Application No. SSD-47105958

Location: 24A Kingscliff Street, Kingscliff

Table 1 - SSD-47105958 Special Report Reviews and Comments

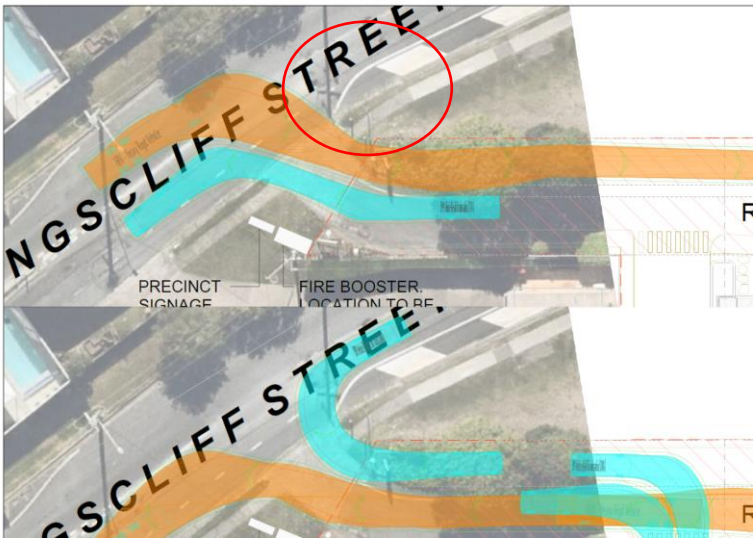
<p>9. Base Sidra Queue Validation <u>No review of existing queues at Beach Street / Kingscliff St or Kingscliff St / Site Access have been undertaken for the purpose of calibrating and validating the Sidra Models to existing conditions.</u> The Sidra Analysis and TIA needs to be updated to demonstrate that the traffic models are developed in accordance with TfNSW guidelines and accurately represent existing conditions.</p>	
<p>Traffic Impact Assessment (TIA) – Prepared by Ptc.</p>	<p>10. Non-Legible Turn Movement Diagrams <u>Traffic turn movement diagrams are not legible within the TIA</u> and also require updates based on the identified flaws within traffic generation and traffic distribution. It is recommended that any updates to the turn movements are clearly shown in the revised TIA</p>	
<p>Traffic Impact Assessment (TIA) – Prepared by Ptc.</p>	<p>11. Traffic Growth Rate The TIA applies a broad 2.0% p.a. growth rate to background traffic to assess the development’s 10 year design horizon. <u>This rate does not accurately consider the forecast traffic growth on surrounding key roads including Kingscliff Street and Beach Street as a result</u></p>

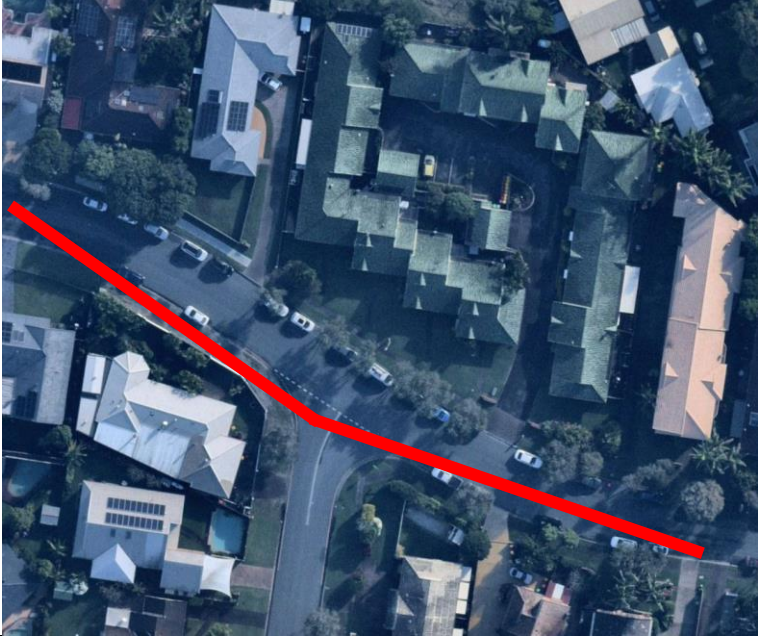
Traffic Impact Assessment (TIA) – Prepared by Ptc.	<p>13. Future Road Links not considered</p> <p><u>The TIA does not consider the future planning of the surrounding road network.</u> Reference is made to Tweed Shire Council's Tweed Road Development Strategy and their ongoing forecast planning which outlines a series of new road links in the region which will change traffic distribution in the surrounding area, particularly for Beach Street, Lorian Way and Kingscliff Street. The forecast traffic growth assessment does not consider these road as well as future developments surrounding the site.</p>	Forecast growth and transport network planning not addressed
Traffic Impact Assessment (TIA) – Prepared by Ptc.	<p>14. Active Transport Network and developments impacts / contribution not considered</p> <p><u>The TIA's review of existing active transport facilities connecting the site to nearby destinations is generic and does not consider Tweed Shire Council's Walking and Cycling Plan (2024), which was open for consultation during the TIA report preparation period.</u> Reference is made to Council's report and its deficiencies raised in close proximity to the subject site along and crossing Kingscliff Street, Pearl Street and Beach Street. The TIA remains silent to</p>	<p>3.3 Active Transport</p> <p>The locality has also been assessed for potential active transport such as walking or cycling options. The vicinity of the site has been assessed to comprise of adequate but incomplete pedestrian infrastructure with potential for improvement. Site frontage roads have footpaths, whilst some surrounding streets are lacking pedestrian infrastructure. Furthermore, there is limited crossing infrastructure to assist particularly vulnerable pedestrians with roadway navigation.</p>

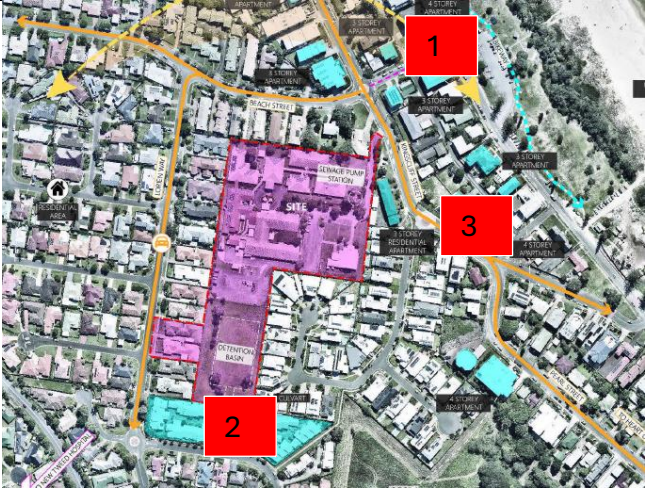
<p>Traffic Impact Assessment (TIA) – Prepared by Ptc.</p>	<p>22. Site Access via Kingscliff Street</p> <p>The driveway access via Kingscliff Street was identified through the consultation phase as non-compliant for accommodating two-way movements and service vehicle operations. No detail is provided in the TIA or Architectural Plan regarding the new driveway crossover design and compliance to Australian Standards and Council's Driveway Design Specification.</p> <p><u>The TIA does not consider the Council maintenance vehicles to access the sewer pump station or internal Padmount and any needs to accommodate larger vehicles such as and Articulated Vehicle (AV).</u></p>

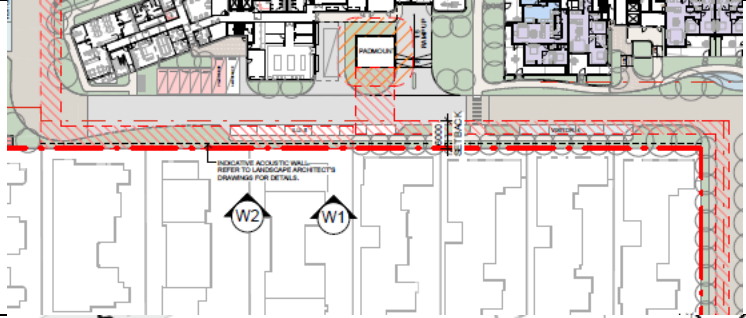
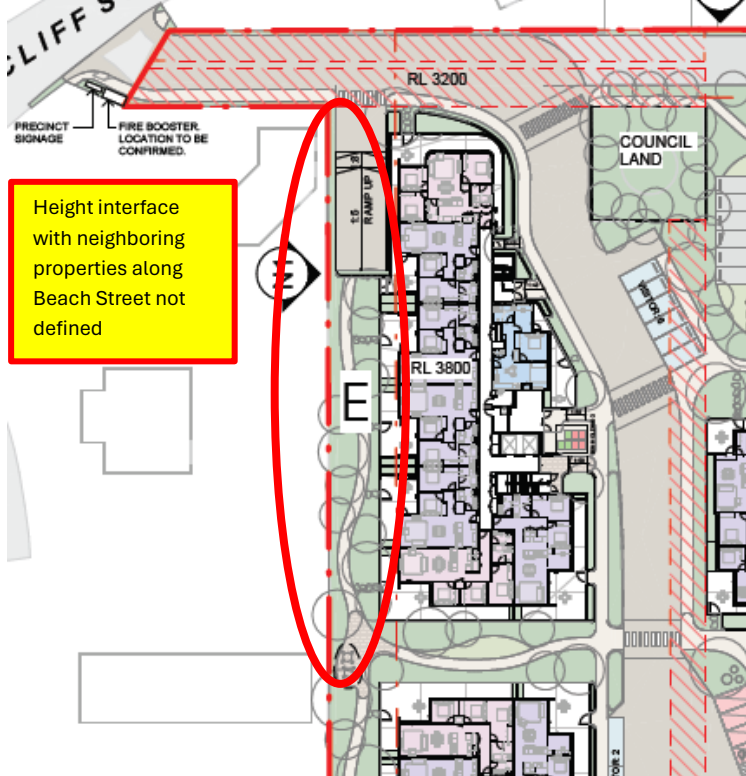
<p>Traffic Impact Assessment (TIA) – Prepared by Ptc.</p>	<p>25. Boom gate on Lorian Way and Kingscliff Street</p> <p><u>The TIA states that boom gates are provided at the site entries on Kingscliff Street and Lorian Way. The Architectural plans and renderings do not show any boom gate control or turn-around facilities.</u></p> <p>AS2890 requires that any boom gate controls provide sufficient turn-around facilities to ensure vehicles enter and exit the vehicle in a forward gear. This includes service vehicles and will also need to consider Council vehicles to access the Sewer Pump Station.</p> <p>The management of boom gate and vehicular control is not outlined and has the potential to restrict parking access by bonafide residents, visitors and staff to the site, therefore resulting in reliance on on-street parking (particularly along Lorian Way and surrounding streets).</p>	<p>6.4 Access Control</p> <p>Parking and site access will be controlled with security boom gates located at both entryways to the site.</p>

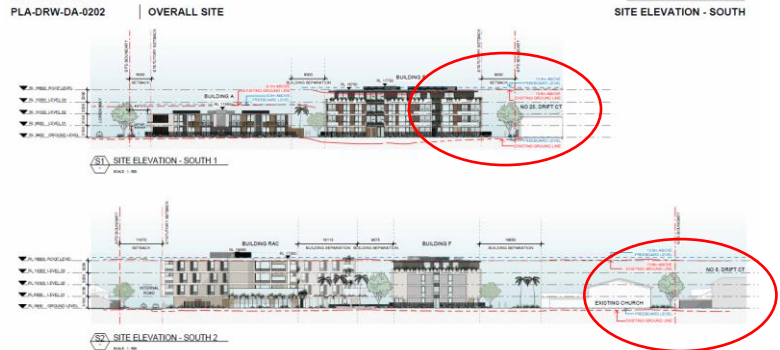
Architectural Plans - Prepared by Plus	<p>30. Tree Removal Along Access Handle to Kingscliff Street</p> <p>Existing survey plan shows established trees along existing driveway to Kingscliff Street on both sides. These are proposed to be removed as part of the driveway upgrade. This impact is not address in the EIS or visual impact assessment.</p> <p><u>These exisitng trees and their proposed removal is not addressed in response to Items 6 and 8 of the SEARS</u></p>	
Architectural Plans - Prepared by Plus	<p>31. Ramp and Pedestrian Sight Line Issue</p> <p><u>The location of the exit ramp will result in vehicles exiting the ramp unable to see pedestrians travelling along the access handle to Kingscliff Street. This sight line issue is exacerbated by providing a pedestrian zebra crossing which provides pedestrian priority. This configuration conflicts with the outcomes of AS2890 and requires reconfiguration to offset the driveway away from the boundary and fencing line</u></p>

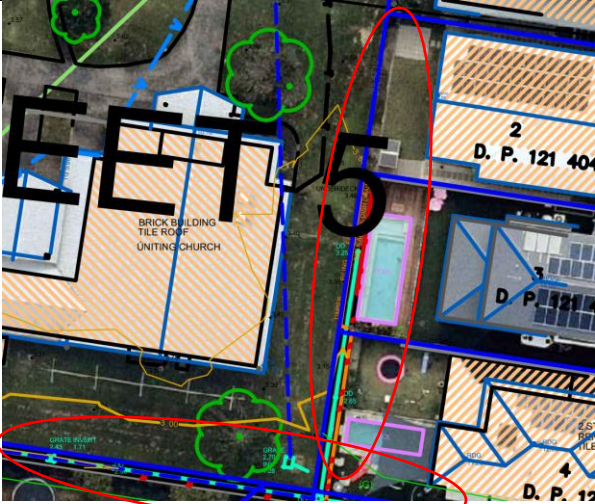
SSD Report Source	Issue / Comment	Item / Reference
<p>Architectural Plans - Prepared by Plus</p>	<p>32. Site Context Plans misinterpret surrounds to substantiate proposal</p> <p>The site context plan references other existing building types to demonstrate precedence of height and land use. <u>The report fails to provide actual context to these examples which demonstrate clear inconsistencies with the proposal.</u> These include:</p> <ol style="list-style-type: none"> 1. Beach Street / Marine Parade examples include ground floor parking recessed into the dune / land scaping with three net levels of units above. Height is taken from 'natural ground level'. The proposal seeks to raise the ground level, then measure heights and levels which is incorrect and misleading. 2. The neighbouring retirement facility is predominantly single storey dwellings only 3. Example 3 on Kingscliff Street, includes ground level parking (no basement and includes the upper level designed into the roof structure façade, therefore reducing the perceived height of the development. <p>It is recommended that site context plans are rectified to more accurately provide the correct context and subsequent differences the proposal has to the surrounding built area, as opposed to similarities.</p>

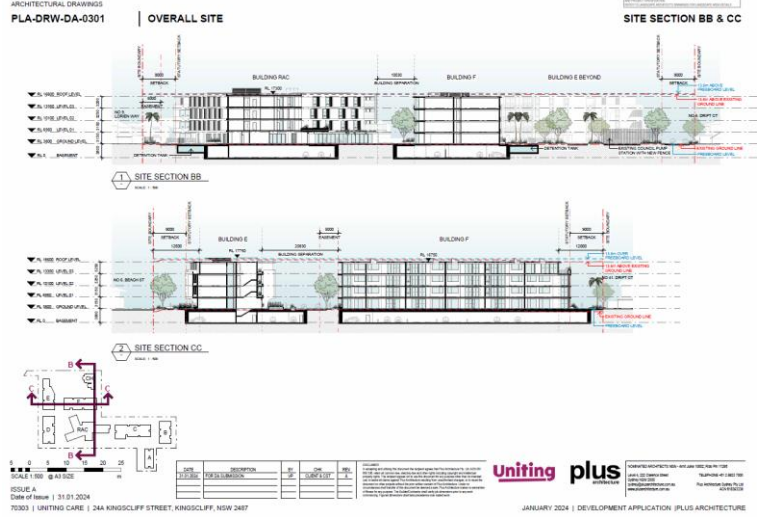
Architectural Plans - Prepared by Plus	<p>30. Deep Planting Zones and Detention basin near Church</p> <p>The plans show proposed deep planting behind the church and in the church car park area as well as detention basis directly adjacent. <u>The architectural plans conflict with traffic and landscape plans for this area along with the levels of both the existing church and surrounding neighbour walls.</u></p> <p><u>The deep planting zone in the car park includes proposed permeable grassed areas which does not comply to AS2890 in maintaining sealed and formalised car parks.</u> In addition, the low point of the site, landscaped batter over basins and basements will likely result in overland flow or pooling in the parking areas. This will result in maintenance issues as well as trip hazard issued for users of the car park (particularly the elderly users),</p>	
Architectural Plans - Prepared by Plus	<p>31. No Deep planting on South-eastern extent of site</p> <p><u>The deep planting zone is not identified along the south-eastern corner of the site, however established landscaping is shown on the ground level landscaping plan.</u></p> <p>It is unclear whether mounds on top of the detention tank are proposed to facilitate the level of landscaping proposed at these locations.</p>

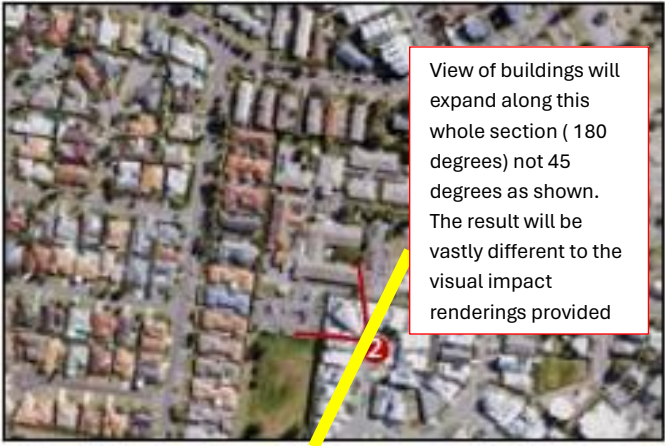
SSD Report Source	Issue / Comment	Item / Reference
Architectural Plans - Prepared by Plus	<p>34. Lorien Way Frontage</p> <p>The plans or 3D renderings do not accurately detail the requirements as outlined in the TIA including boom gate and turn-around facility as well as pedestrian sight triangles on both sides of the driveways.</p> <p>This issue needs to be addressed across multiple reports including visual impact assessment and landscaping reports</p>	 <p>The diagram shows a site plan with Lorien Way at the bottom. A building footprint is shown with setbacks of 6000 on both sides. A red circle highlights a specific area near the road, labeled 'RL 3380'. Other labels include 'SIGNAGE BOOSTER & METER' and 'SETBACK'.</p>
Architectural Plans - Prepared by Plus	<p>35. Church Car Park Compliance</p> <p>Car park for church does not comply with AS2890. It includes a blind aisle and also large proportion of grassed aisle / surface. The configuration will result in uneven surface and muddy due to vehicle parking movements and positioned as the lowest part of the site. This configuration will also be a trip hazard for elderly / vulnerable users which are expect to make up a significant proportion of users.</p> <p>The church car park has also not been checked for service vehicles or hearse movements.</p>	 <p>The diagram shows a site plan with a '38 BAY CARPARK' and a 'CHURCH' building highlighted in yellow. A red circle highlights a specific area within the car park. Other labels include 'SETBACK' and 'CIL'.</p>

PLAN ILLUSTRATING CAMERA LOCATIONS

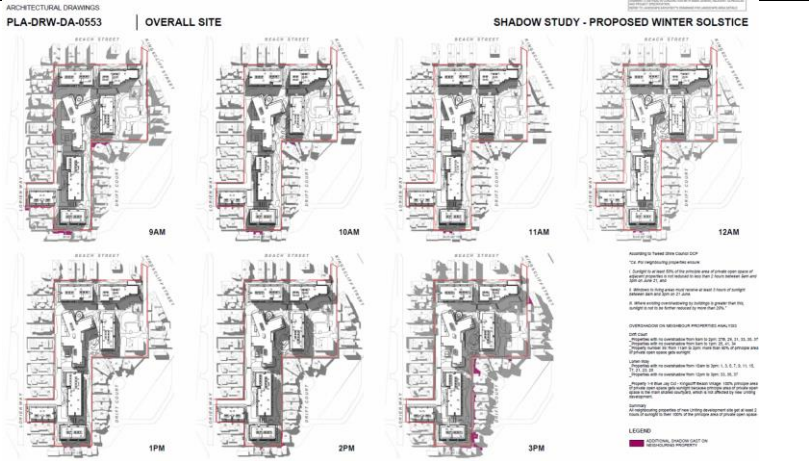
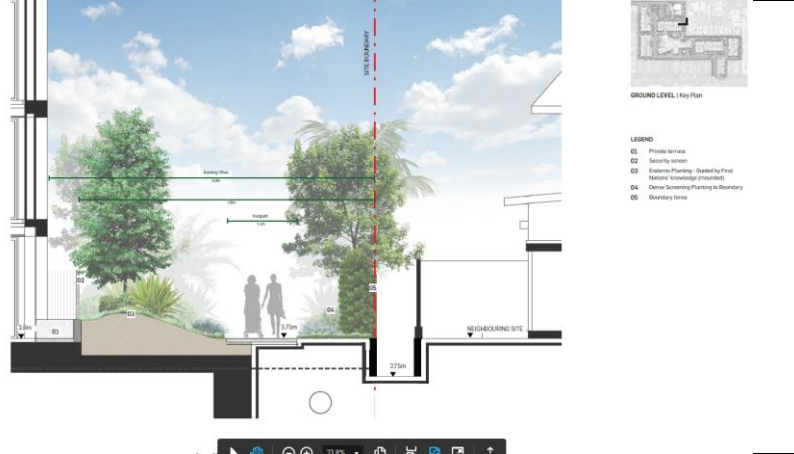
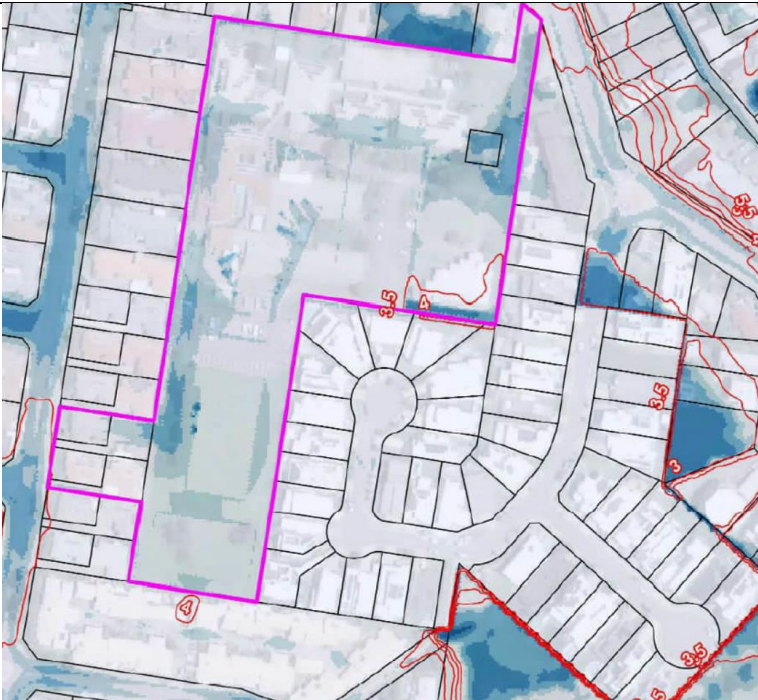
Photo Date:	8 August 2023							
Camera Used:	Canon EOS R5							
Camera Lens:	26mm							
Visual Impact Report – Prepared by Ethos Urban	<p>47. Lack of viewpoint from Drift Court (No.s 25 to 35).</p> <p>Properties 25 to 35 Drift Court are expected to have a significant impact to privacy, visual, amenity and shadows as a result of the development. These properties are not adequately addressed as part of the visual impact assessment. It is recommended further detailed visual impact renderings are undertaken to address these concerns.</p> <p>Updated location are shown adjacent.</p>
